Item No. 5 Transcona West Area Structure Plan
(Transcona Ward)
File SP 1/2006

Date: **October 8, 2007**
File: **SP 01/2006 SUPPLEMENTARY REPORT**
Subject: **Transcona West Area Structure Plan**
Location: **South of Cordite Road, east of Plessis Road, north of Regent Avenue and west of Lagimodiere.**

Proposed Amendments to the Secondary Plan

Figure 1

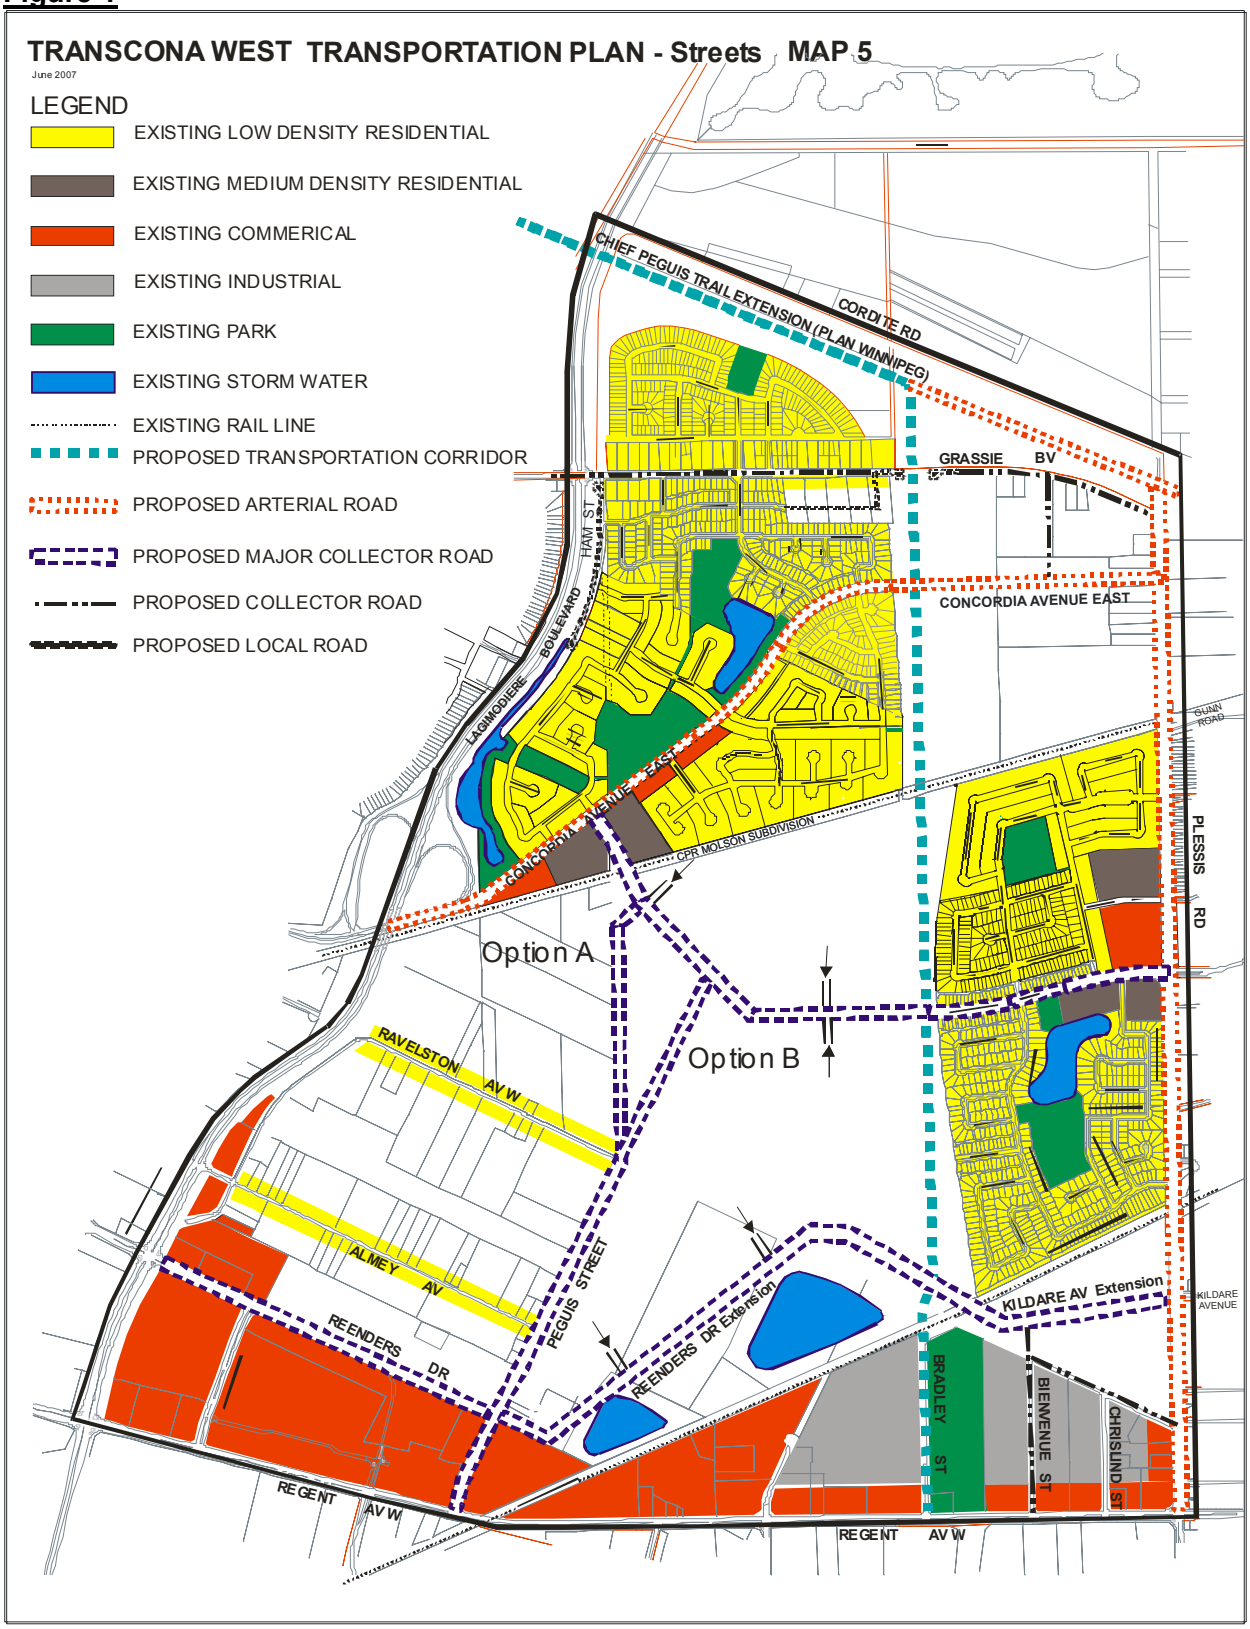
a) The current map should be labelled "Map 5 - Option A"
b) A new "Map 5 - Option B" should be developed as per Councillor Wyatt's submissions (*See* Figures 1 and 2*)*, incorporating a public works yard on Plessis Road as part of a special planning area and a provision for a rapid transit corridor/station

The Public Service would not support these amendments. The suggested amendments to Map 5 suggests three (3) radically different routes for Peguis Street and its connection to Devonshire Drive (Figure 1). This is contrary to the conceptual nature of the Area Structure Plan since it does not provide clarity or guidance to future developments, land-owners, planners or decision makers. Confusion over the Peguis Street route will be formally adopted and the exact route will need to be settled through the DASZ stage. The secondary plan will not be a tool of development since it does not provide guidance and becomes redundant.

Figure 2

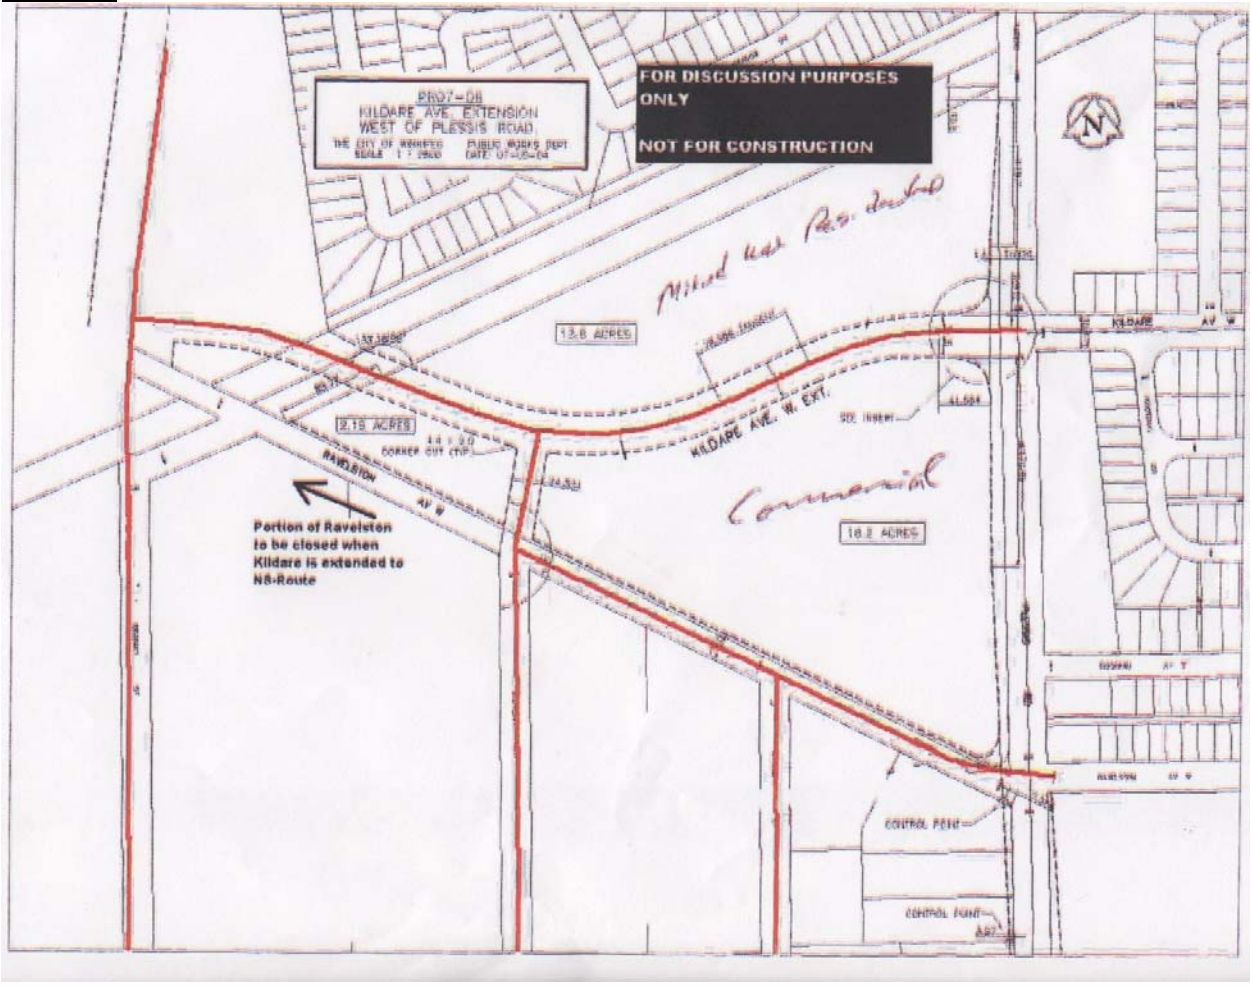
Mr. Wintrup also noted that the Kildonan Extension Map in Figure 2 appeared to be contrary to Plan Winnipeg Policy Plate C and would require comment from Legal Services as to whether it could be done conceptually or whether a regulatory change would be required.

The Kildare Extension Map in Figure 2 appears contrary to Plan Winnipeg Policy Plate C. The current Plan Winnipeg Policy clearly illustrates the N/S route using Ravelston Avenue West whereas the proposed amendment indicates the N/S Route along Bradley Street, and Ravelston Avenue being eliminated. However, this Policy Plate has been treated as both 'conceptual' and 'regulatory' thus the Kildare Extension as illustrated will require comment from Legal Services as to the ability for it to occur and be included in the Secondary Plan since conformity with Plan Winnipeg is a legal requirement.
